Technical Service Bulletin

COMPLIANCE: ADVISORY
SUBJECT: LOWER IONIZATION DUE TO COILED HIGH VOLTAGE CABLES
AFFECTED UNITS: ALL GPS-IMOD™ UNITS
DESCRIPTION:

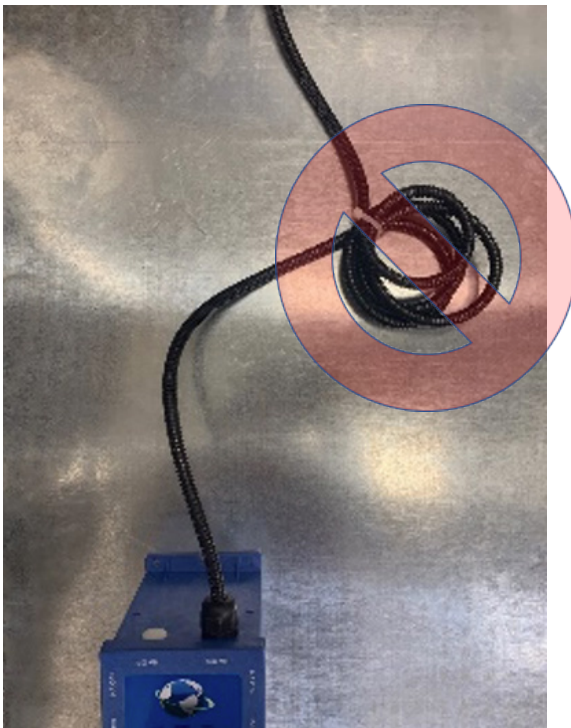
The coiling or bundling of high voltage (HV) cables can cause arcing and decreased ion output from the iMod. Installations where the cable(s) are touching in multiple locations will experience reduced output and lifespan. If the HV cable(s) is similar to the below picture, action is strongly recommended.

Do not cut or alter high voltage cables. Cables 15ft long can be ordered if additional length is required. Do NOT coil, bunch, or loop the cable up so that it comes in contact with itself. To reduce slack in the cable, create long sweeping "S" shapes, like switchbacks in a road. High voltage cable should be routed with soft bends only such as creating long sweeping "S" shapes. Minimum bend radius is 3". Maximum bend angle is 70 degrees. Secure the cable(s) so they will not interfere with or be damaged by equipment or personnel.

The proper routing of cabling is shown above.
